Decision Report

Application for licence

| Licence number | L9330/2022/1 |
| Premises | 'Koojan Downs' Cattle Feedlot 1131 Boundary Rd YATHROO WA 6507 |

▲ Figure 3: Effluent utilisation areas (green circles)

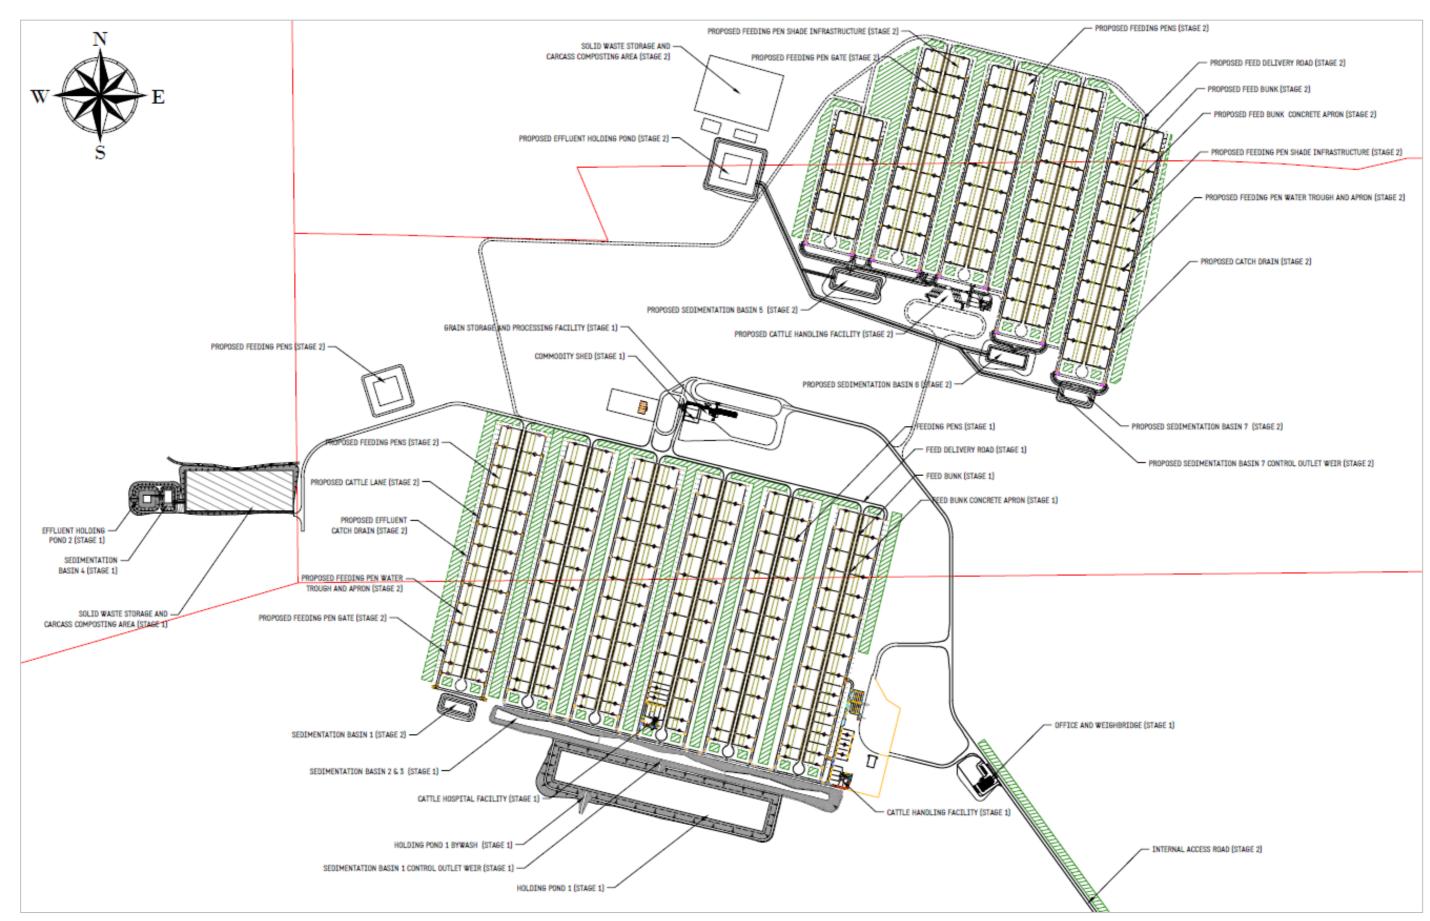
The delegated officer has expressed concerns with the suitability of the proposed effluent irrigation areas, given:

- the characteristics of the soils within the proposed effluent irrigation areas (pale deep sands) will require careful management and regular monitoring to ensure that nutrient leakage to groundwater and other forms of land degradation do not occur from effluent irrigation;

- saturation of soil P levels within the initial effluent irrigation areas are expected after about 3 years of operation, meaning new irrigation areas will be required to support ongoing effluent irrigation after about year 3;

- groundwater levels beneath the proposed effluent irrigation areas are shallow; it is unclear how the applicant intends on maintaining groundwater levels below 2 mbgl and what remediation, management or operating procedures will be implemented should groundwater become contaminated with nutrients;

- the applicant expects irrigation will predominantly occur during November to March; however, the delegated officer expects that irrigation will more likely match effluent accumulation, including during winter due to storage limitations, enhancing the risk of over-application of irrigation and leaching; and

- it is noted that a utilisation area may be 'spelled' from effluent application until nutrient levels are returned to sustainable levels by crops. It is unclear whether the crops used to strip out elevated nutrient levels require irrigation.

In response, the applicant updated the nutrient and irrigation management plan (RDC 2023) to demonstrate how it proposed to manage the irrigation of effluent and ensure nutrient leaching to groundwater does not occur.

In summary, the applicant proposes to monitor soil phosphorus levels within the effluent utilisation area on an annual basis, prior to the first application of each season. Should monitoring indicate soils within the effluent utilisation area are becoming saturated with phosphorous, then effluent will not be applied to those areas until monitoring indicates a reduction to sustainable levels. Crops will continue to be grown within the affected areas to remove phosphorus and irrigation will be with clean groundwater.

Monitoring of groundwater levels and quality commenced under the works approval and will continue under the licence. Should monitoring indicate elevated levels of nutrients, an investigation will be conducted to determine whether the source is attributed to over

application of effluent. The NIMP indicates the proposed contamination management strategy would be groundwater recovery followed by monitored natural attenuation.
